**Public consultation on the methodology, the basis data and scenarios used for the study regarding the adequacy and flexibility needs of the Belgian power system for the period 2022-2032**

## **Comments from Greenpeace and Inter-Environnement Wallonie**

**30 November 2020**

## Aandeel hernieuwbare energie in België

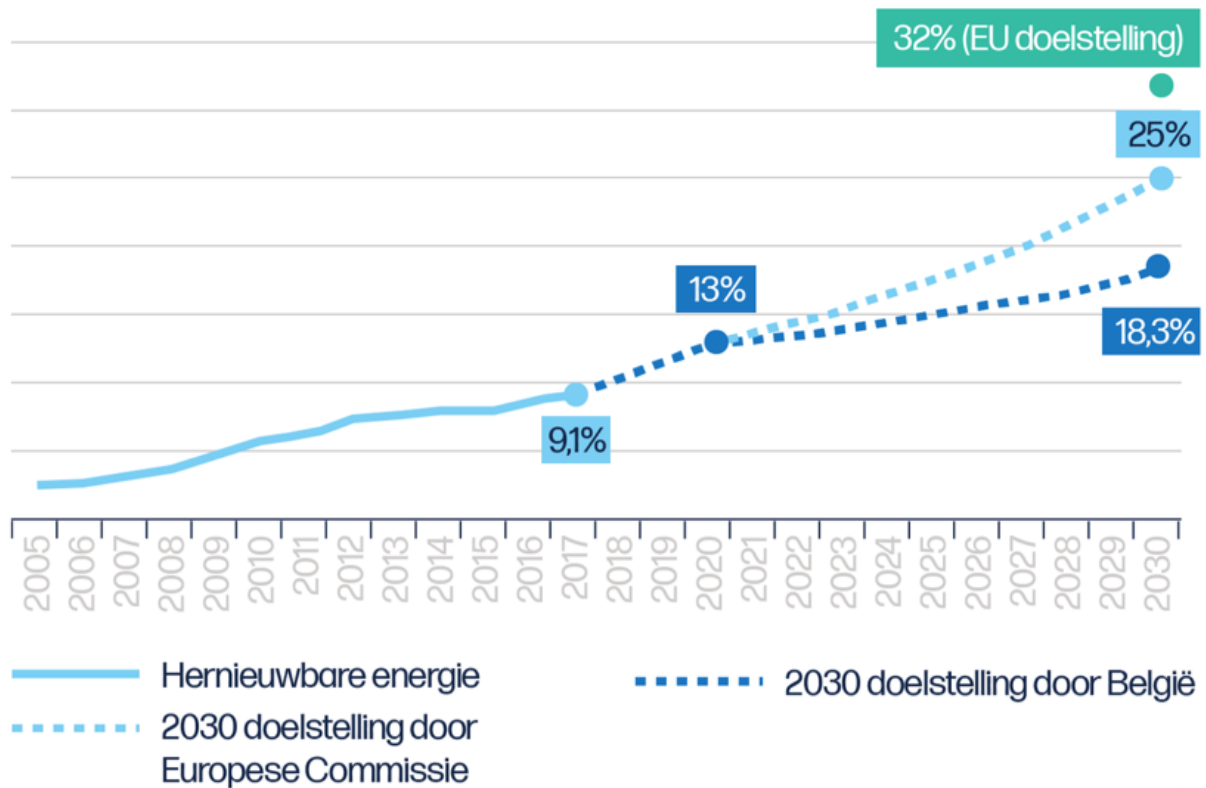
The objectives for renewable capacities for Belgium as mentioned in sheet 1.2. are based on the 2019 NECP. This is however not compatible with the objective set by the federal government to align the Belgian policy with the -55% EU GHG emissions reduction by 2030. The 2019 NECP figures thus need to be updated.

- a. Use the objective set out in the federal government agreement as a basis for the reference/central scenario, and not the outdated 2019 NECP.
  - i. For offshore wind, the reference scenario should include the objective of 4.4 GW (and not 4 GW) by 2028, with a first phase of 700 MW to be finished in 2026.

- b. Add a high-renewable sensitivity (High-RES) with ambitious but realistic objectives for solar and wind energy. The proposed scenario below is an update of the 2016 Our Energy Future scenario of Greenpeace, BBL and IEW. We also add for informational purposes the High-RES scenario of [Energyville 2020].

- i. For offshore wind, the High-RES sensitivity should speed up the deployment of the 4.4 GW by the end of 2025 instead of 2028, as mentioned in the federal government agreement.

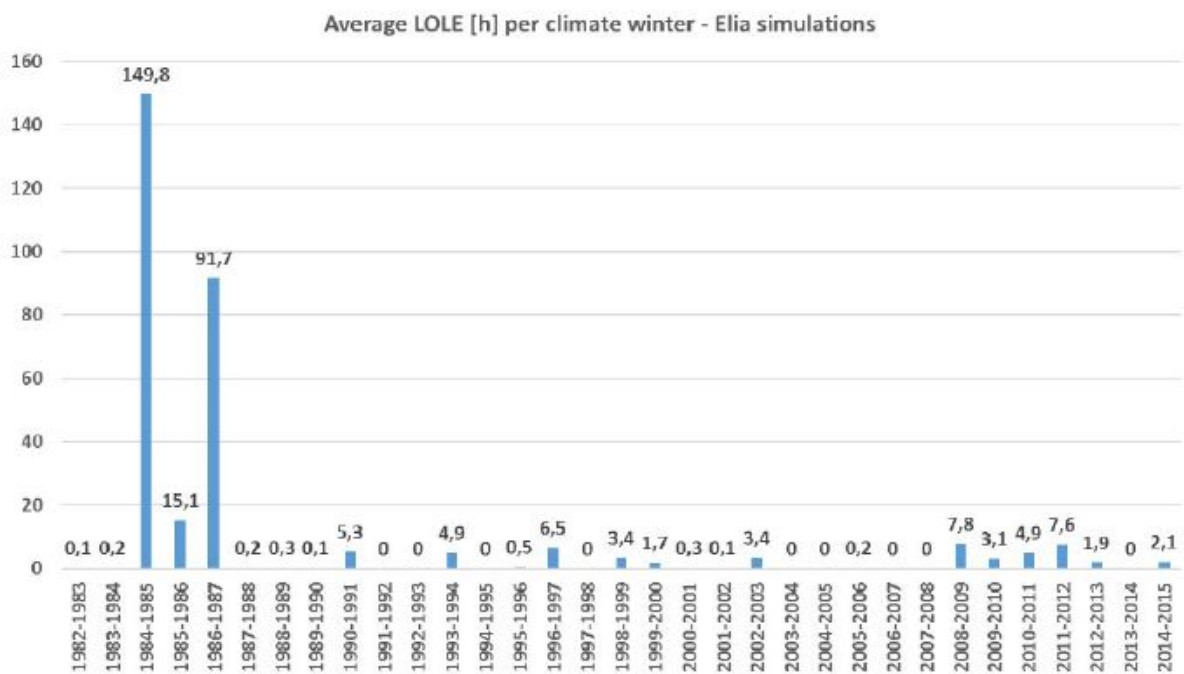
- As demonstrated in Study 2064 of the CREG and the VUB study “Winter is Leaving”, there is a major impact of the climate years methodology on the outcome of the Adequacy calculations. It is therefore imperative that the 2021 Adequacy & Flexibility study is very transparent on these calculations.
- As such, it is positive to implement option 1 of the ERAA methodology, because the future trend in climate change might have a fundamental impact on the Adequacy calculations.
- However, if this would not be feasible, it must be made clear what the alternative methodology will be, which is now excluded from this consultation. An alternative approach will be “proposed”, but will there be a consultation on this?
- In addition, the RTE methodology is a black box. How will this methodology be made transparent?

We propose that, whatever methodology is followed, a detailed data set is made available which makes it possible to evaluate e.g. what climate years are responsible for how many LOLE hours, similar to the graph below and calculated by Elia on request of the CREG, but regrettably not included in the 2019 Adequacy & Flexibility study.
